INTER-OFFICE LETTER

MR. W. A. BARNES	ATLANTA	(B)	FROM	A. I. JOHNSON	DATE 8/30/68
MR. F. A. DELEHN	LOS ANGELES	(B)			
MR. A. MHI	BRANALEA	(B)	OFFICE	DIRECT SERVICE ENGINEERING	
MR. A. MINICK	DALLAS	(B)			
MR. T. C. PETERSON	CHICAGO	(B)	SUBJECT	F.E.R. 68-8	
MR. L. STURZENBERGER	NEW YORK	(B)		19R CONDENSER PURGE BAFFLE	
MR. R. VAN DERPOOL	COC ADA	(B)		<u>SEALING STRIP FAILURE</u>	
MR. H. E. GRIFFIN	LOS ANGELES	(C)			
MR. W. H. GUNTHER	NEW YORK	(C)			
MR. H. A. JOHNSON	DALLAS	(C)			
MR. R. T. MITCHELL	CHICAGO	(C)			
MR. J. MOSES	ATLANTA	(C)			
MR. R. VAN DERPOOL	COC ADA	(C)			
MR. R. JOHNSTON	TR-20	(C)

FIGURE 1

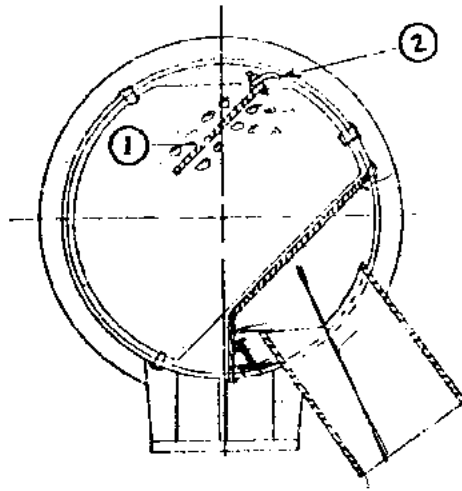
Background - From approximately 9/62 until 1/68 the purge baffle sealing strip used on 19R condensers was constructed as in Figure 1 below. Experience has shown that it is possible for the purge baffle to flex and warp enough to shear the 1/4" bolts holding the assembly together. These sheared bolts usually end up in the condenser float valve chamber. Several problems may result from the broken bolts:

- 1) The bolts may jam the float valve open leading to machine hunting and other problems.
- 2) Vibration of a loose back up bar may cause noise in the condenser.
- 3) Sheared bolts and nuts may lodge between tubes leading to tube leaks.

FIGURE 2

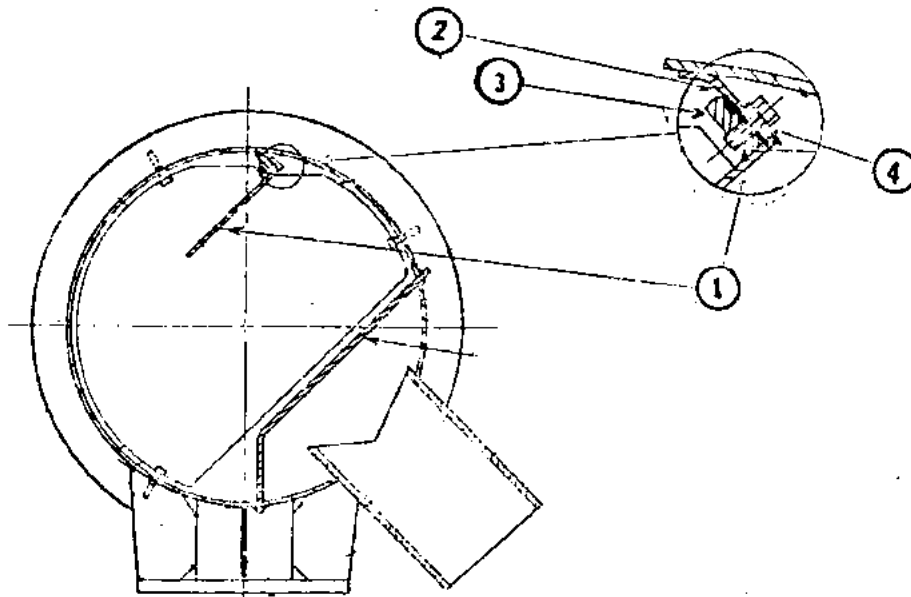
*Modified*  
 Condensers serial number 11141 and higher have an improved sealing strip arrangement. The neoprene strip is now bolted with 3/8 high strength bolts to a perpendicular support bar that stiffens the purge baffle. This arrangement is shown in Figure 2.

FIGURE 3  
SHELL CUTTING DETAILS

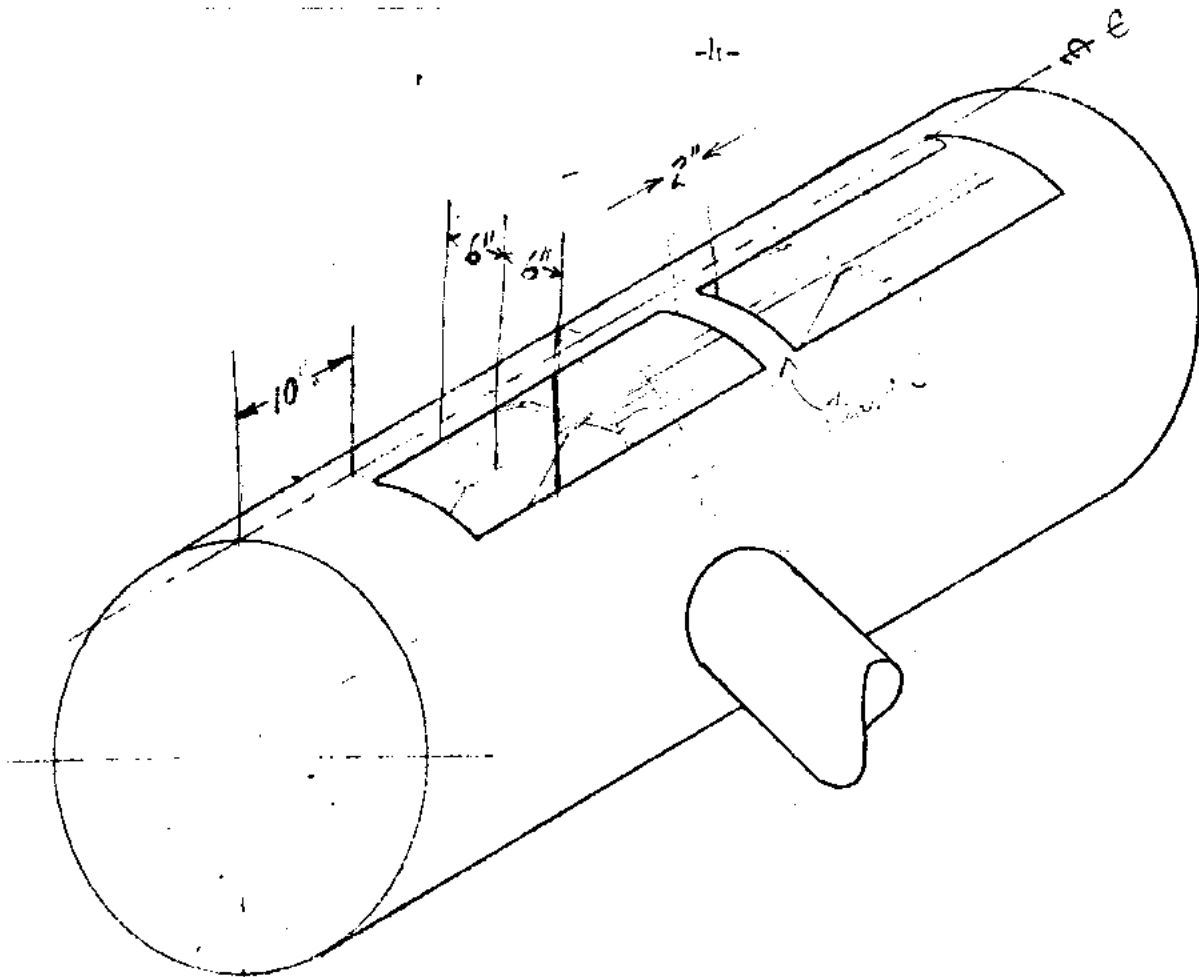
Repair procedure - Cut a narrow circumferential slot from the top of the shell down around the shell toward the discharge side to locate the purge baffle. Then cut out two horizontal sections extending approximately 6" above and below the baffle. See Figure 3. Leave one circumferential strip intact to prevent the shell from going out of round. NOTE: Condenser water must be flowing while the shell is being cut to prevent tube damage.

FIGURE 4  
MODIFIED BAFFLE ASSEMBLY

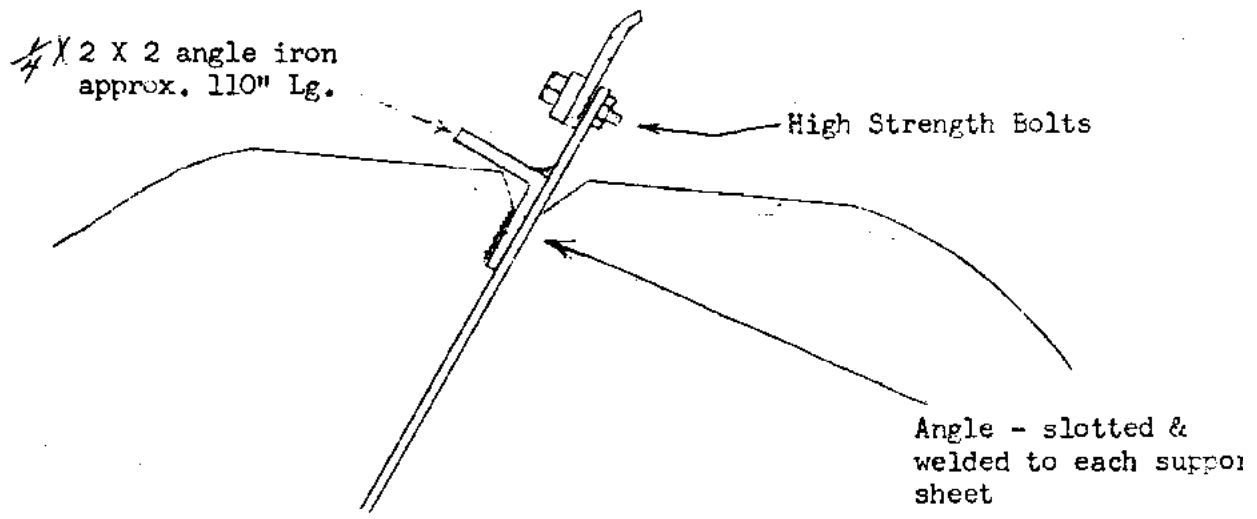
Slot a 2" angle iron so that it will fit around the support sheets then tack weld it to the support sheet and to the purge baffle, Figure 4. The angle iron running the full length of the purge baffle dampens the vibration of the baffle. It is this vibration that leads to the fatigue failures of Figure 1 sealing arrangement.

Use 3/8" high strength bolts rather than the standard 1/4" bolts to hold the cloth inserted neoprene sealing strip to the baffle. The nut must be locked to the bolts. Several methods have been used including Loctite, double nuts, oval nuts and disturbing the threads. Loctite and disturbing the threads are suggested. Repair the shell using ASME techniques.
